Date Created : 2007/12/25
Date Issued On : 2008/01/03
PCN# : Q4075201

INFORMATION ONLY NOTIFICATION

Change Type Description: Information Only

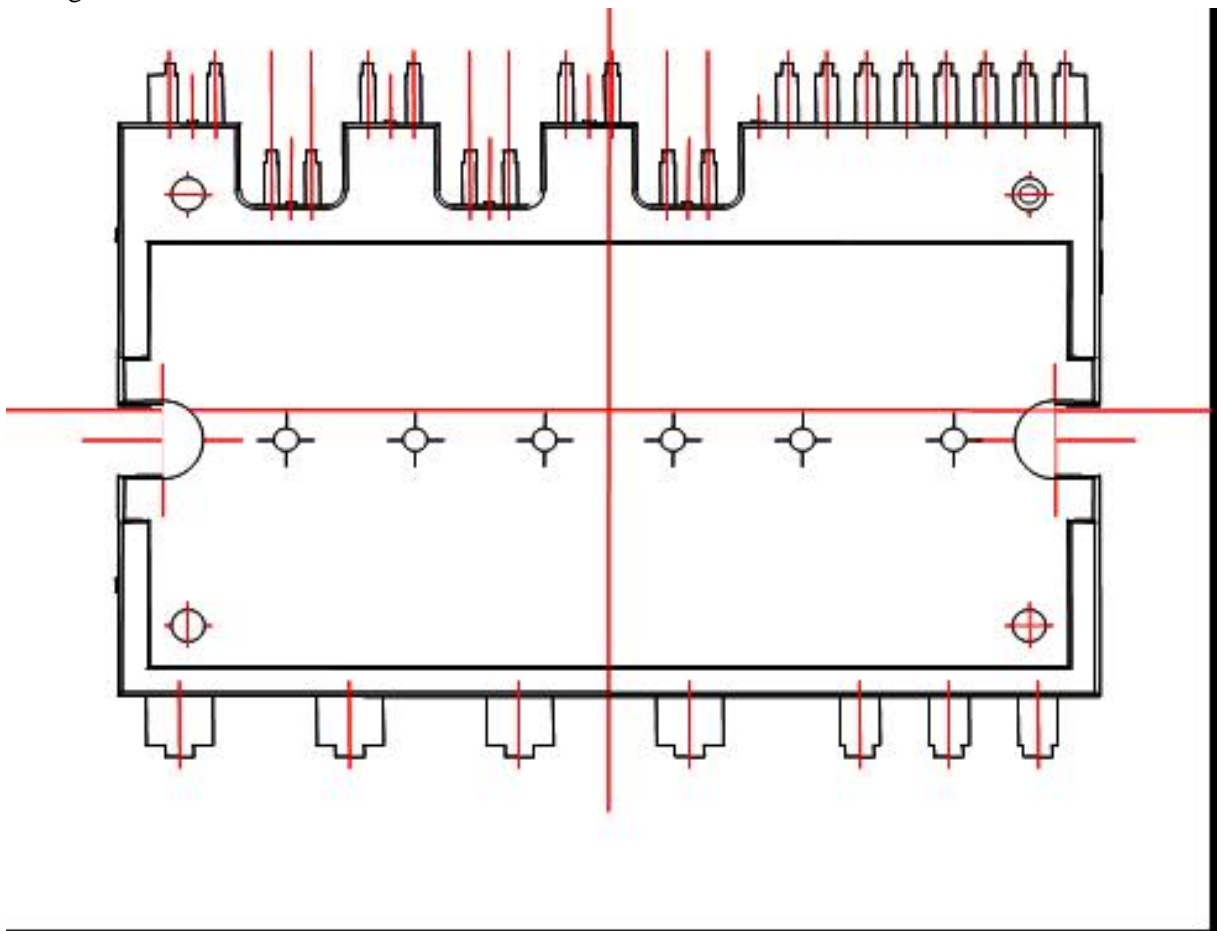
Description of Change (From): Bottom Retract pin position in signal pin side

Description of Change (To): Bottom Retract pin position in signal pin side in Center area

Reason for Change : Quality improved by increasing mold ability
